S E R V I C E N O T E

**66309D - Mobile Communication DC Source, Dual-Output
15V/3A,12V/1.5A. GPIB**

**Power-On Self test Errors, Auto reboot, Blank display. No output Communication errors.
No communication when using the GPIB Interface.**

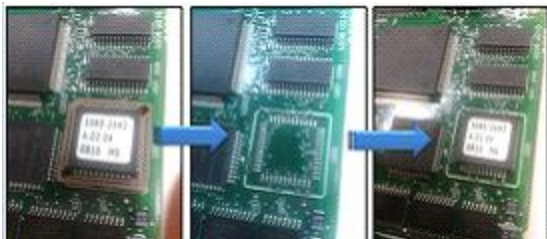
When the EEPROM is installed in the PLCC SOCKET (**Circuit Reference U205**) on the Interface board if there is not a gas tight connection between the EEPROM pins and the socket pins an intermittent connection will occur.

It has been determined when removing the socket and soldering the EEPROM (circuit reference U205) directly on the interface assembly “A2” would be very difficult (See Picture below), even having the correct tools, removal of the socket and replacement of the EEPROM is very difficult and may cause additional quality and reliability issues.

1. This problem can be solved by replacing the GPIB Interface assembly. See above for the tested interface P/N that is required to repair the instrument. The correct tested assembly for the specific model must be used when repairing a defective instrument.
2. This problem can also be solved by removing the socket (circuit reference U205) on the “A2” interface assembly and soldering the **Original** EEPROM directly to the Printed Circuit assembly.
